### ADDENDUM TWO

Project: Cleveland St. Streetscape Phase III & Festival Core

Date:	March 4, 2021
Project No.	<b>Cleveland Street Streetscape Phase III, 16-0003 EN &amp; 19-0026-EN</b>
To:	Catherine Corcoran, RLA
From:	Christina M. Newcomb, PE
Subject:	<b>RESPONSES TO CONTRACTOR'S QUESTIONS – PRE-BIDDING PHASE</b>

CLEVELAND STREET PHASE III  
AND FESTIVAL CORE  
DEMOLITION PLAN

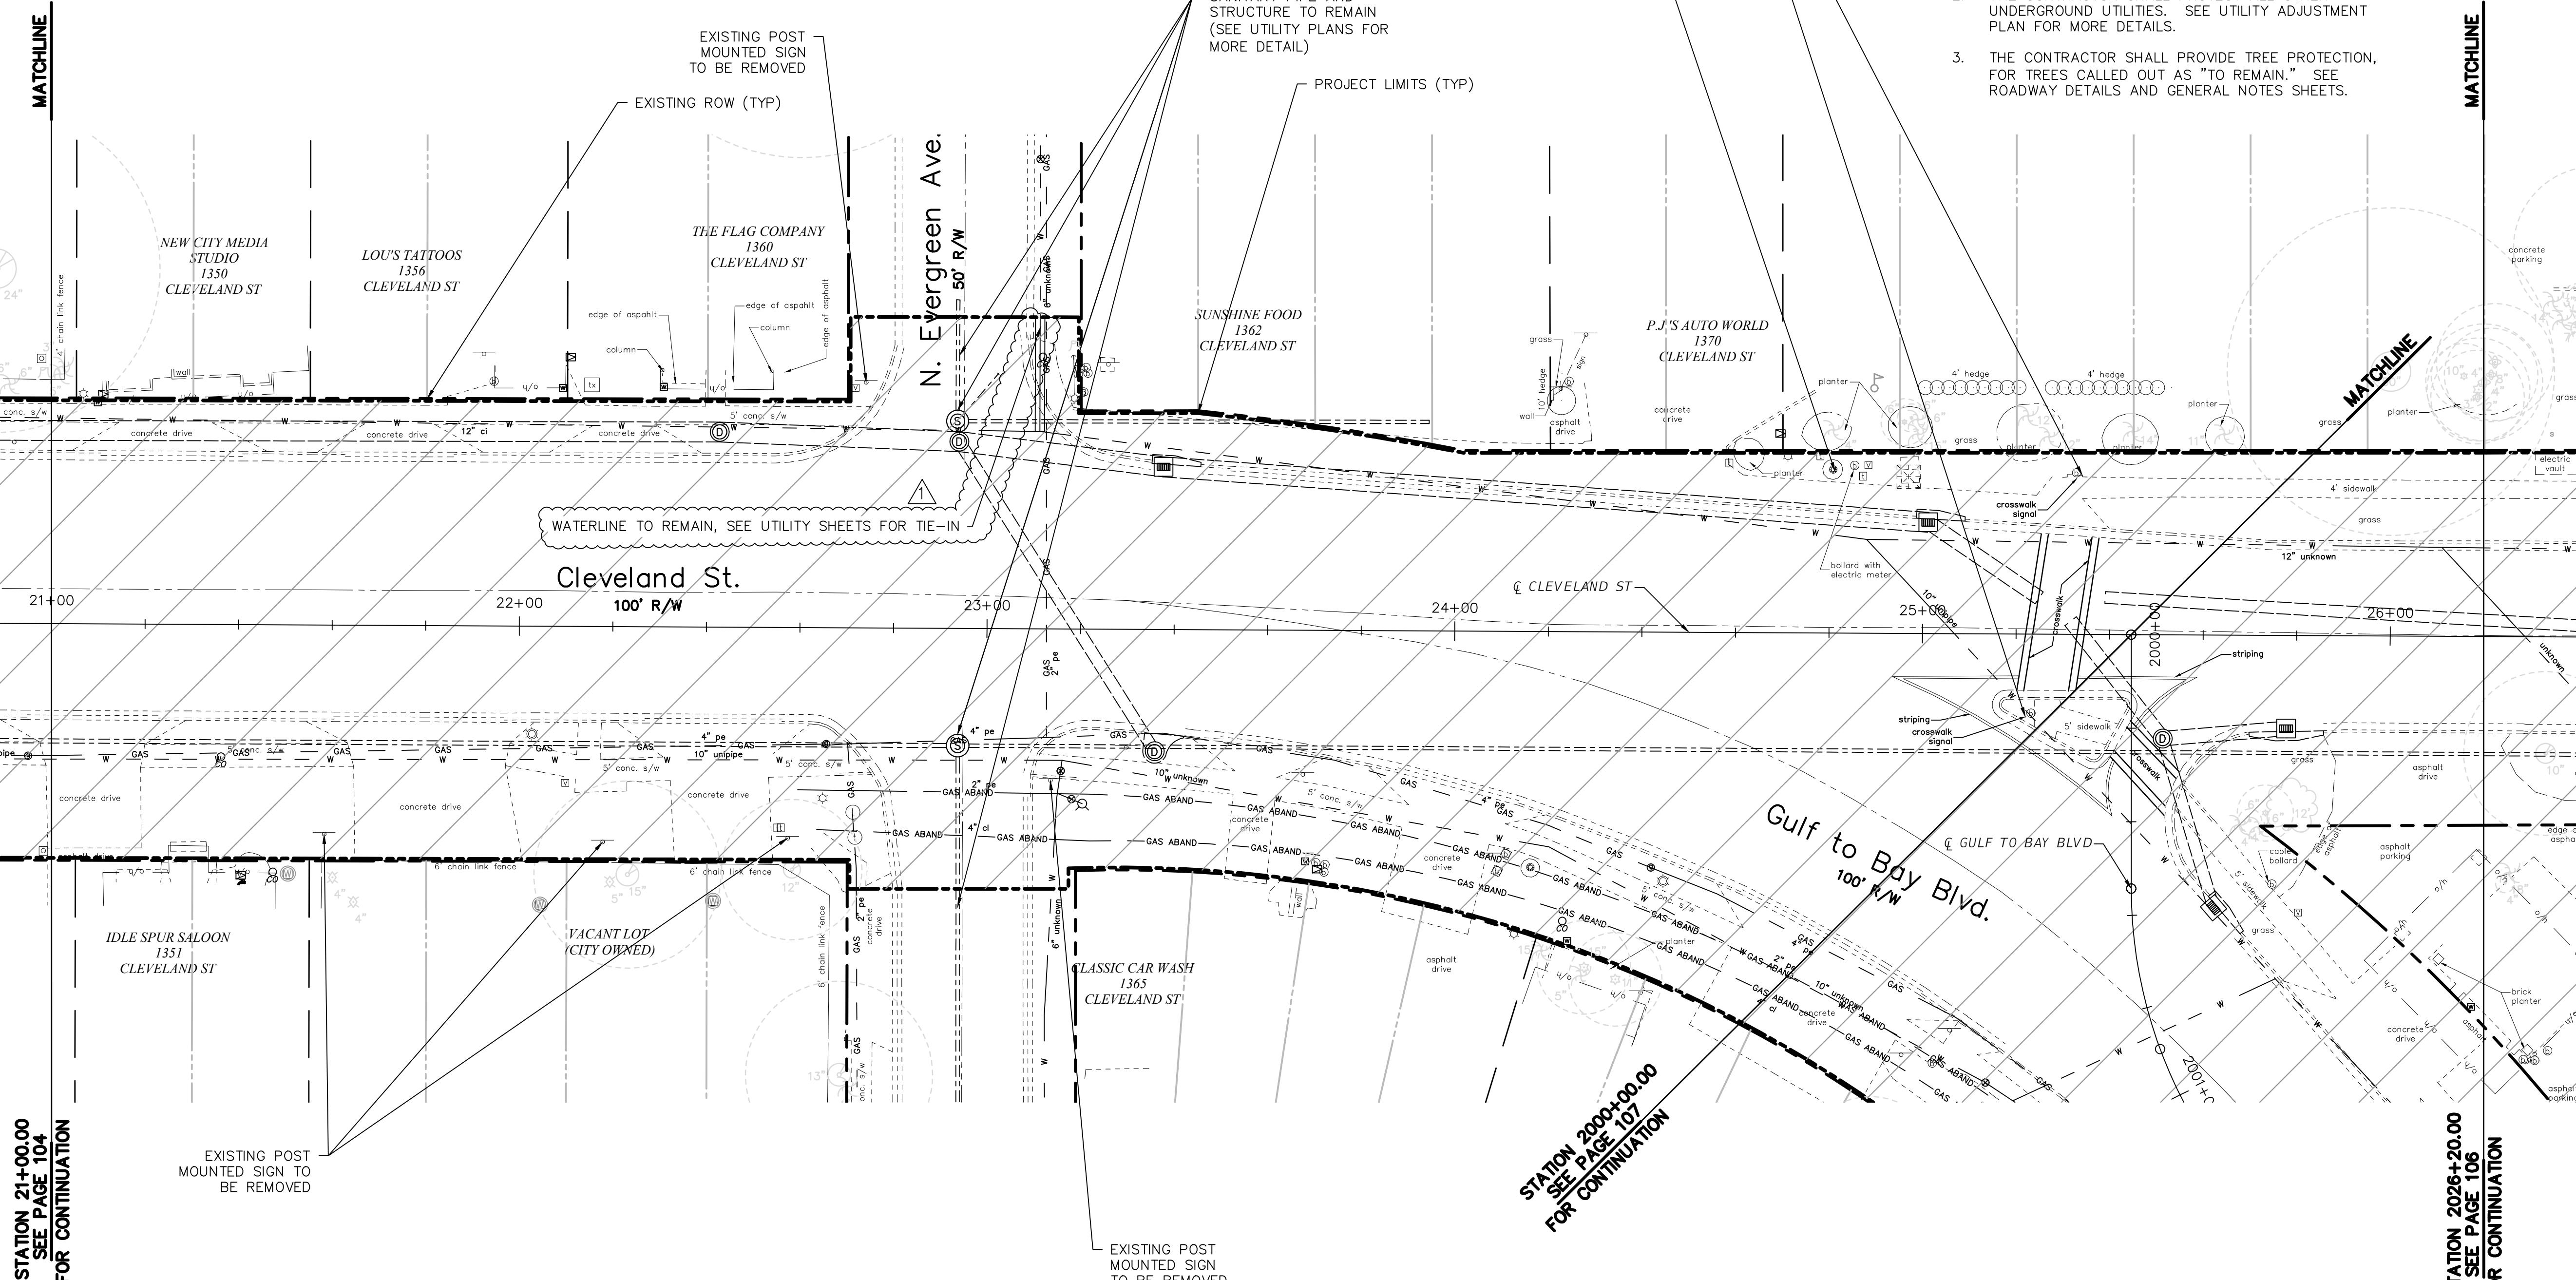
9. Sheets 105 and 107 indicate for removal of existing signalization. Please clarify if this is by the contractor and if so provide a pay item.

***Response: The Contractor shall coordinate with City of Clearwater staff, who will remove the traffic signals at Cleveland/Gulf-to-Bay and Park/Gulf-to-Bay and adjust the signal at Cleveland/Missouri.***

1 CORNER TREATMENT AT GRADE  
353 SCALE: 1/4"=1'-0"

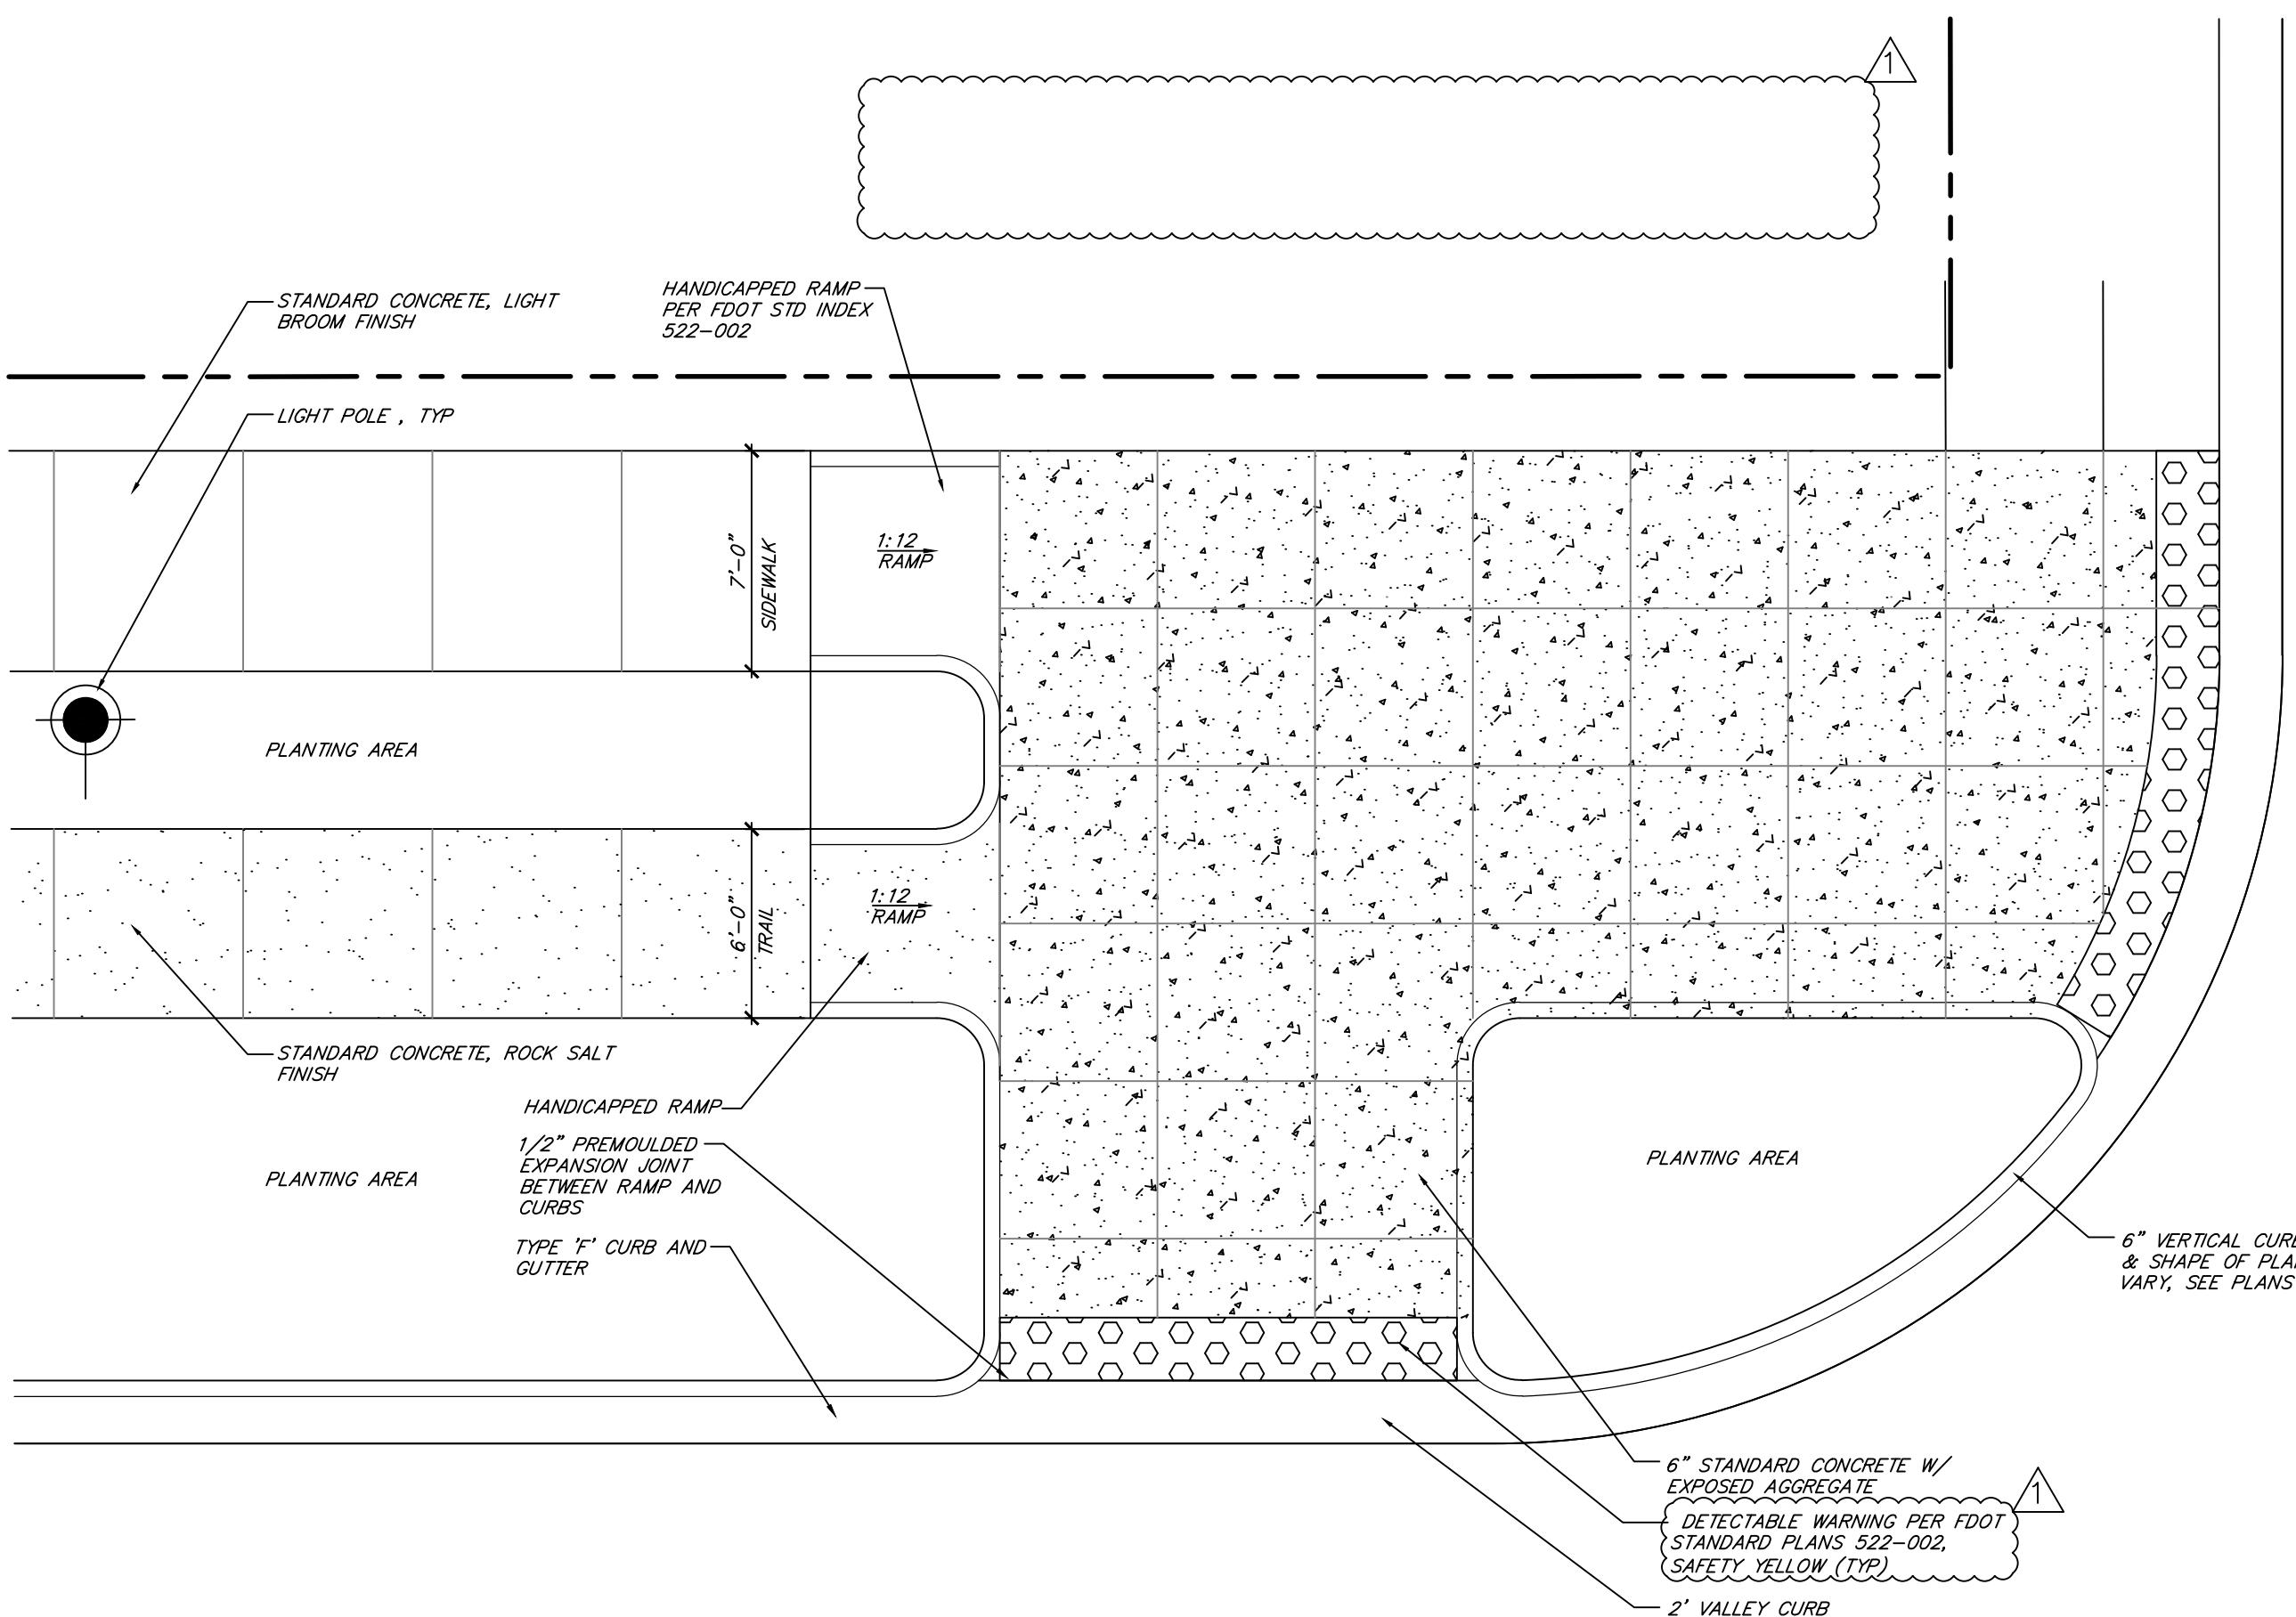
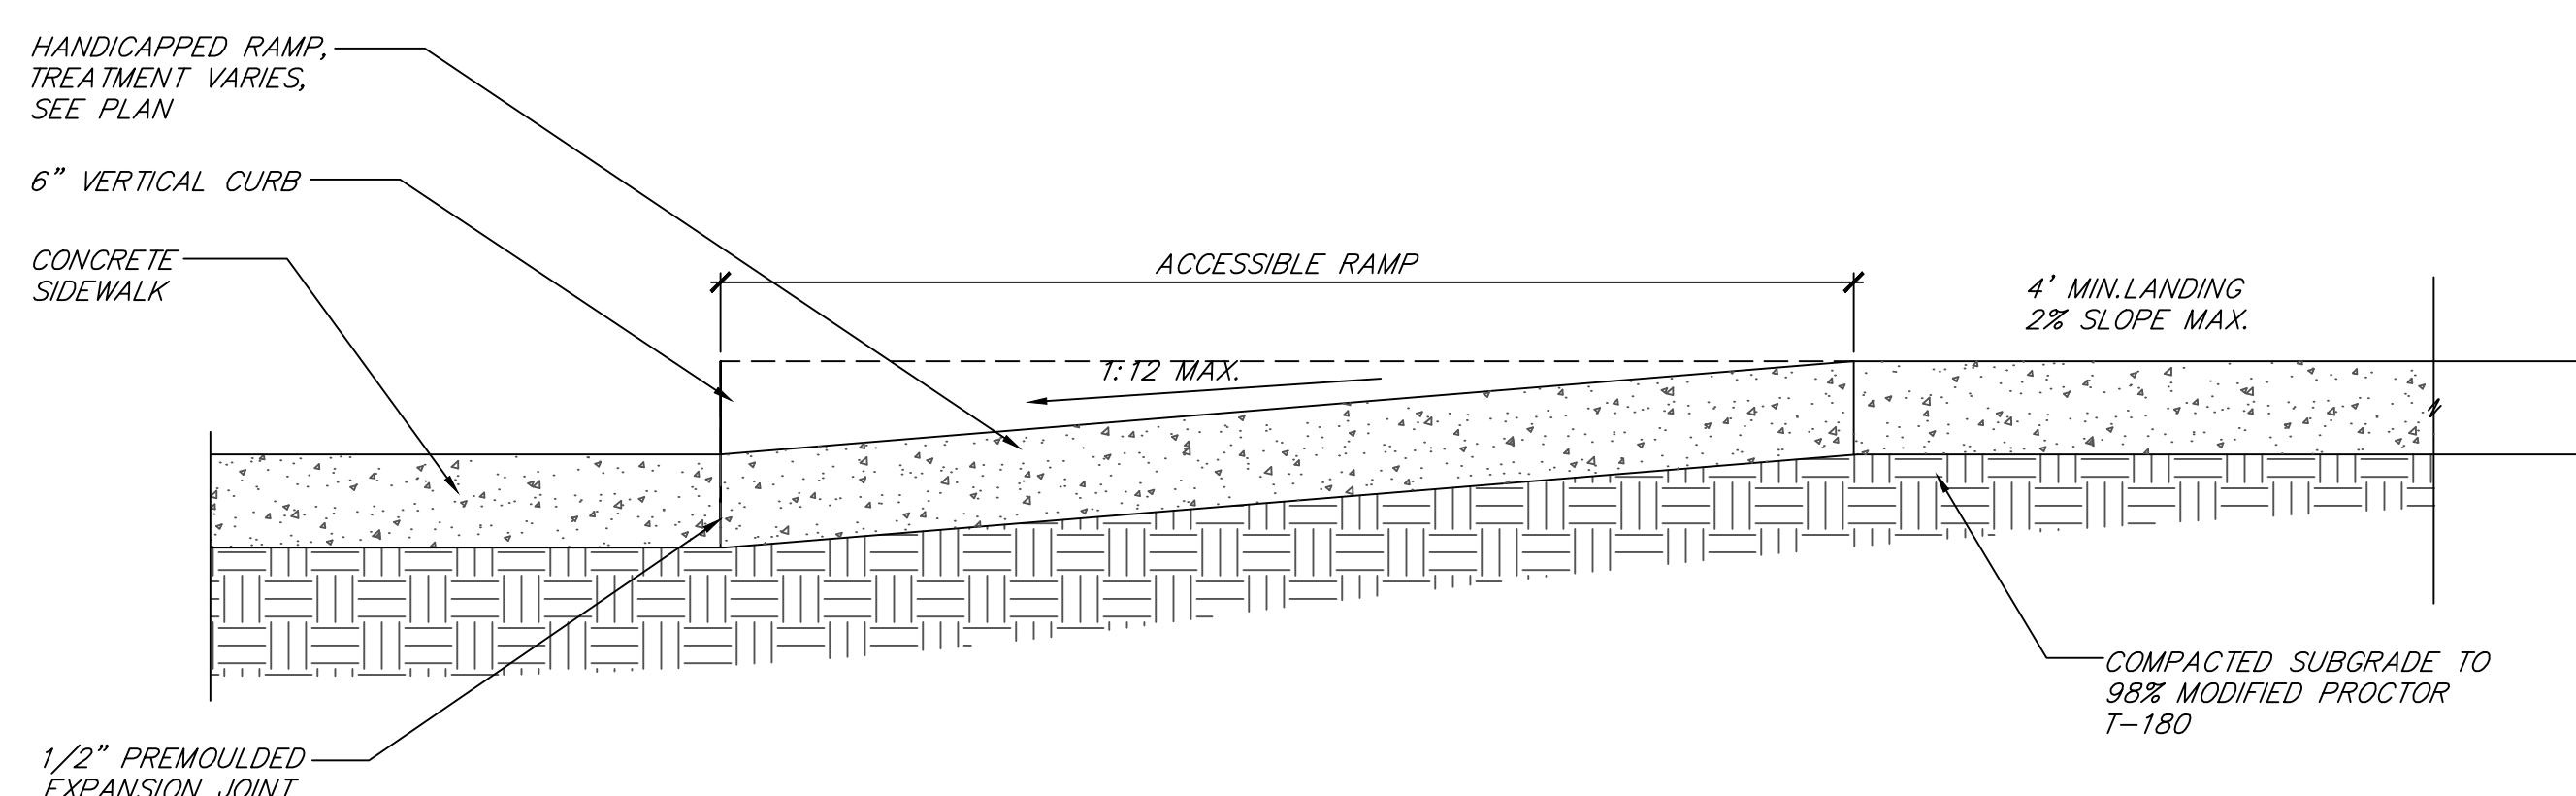
1. On sheet 353 there is a note that reads that the detectable warning surface is by Hanover Architectural Products or approved equal. Since these are pavers will a concrete slab be required under the pavers? Please provide a typical detail. Also please provide a pay item and quantity.

***Response: the detail will be update to provide for detectable warning strip in accordance with FDOT standard plans 522-002, Safety Yellow. A pay item and qty will be added.***
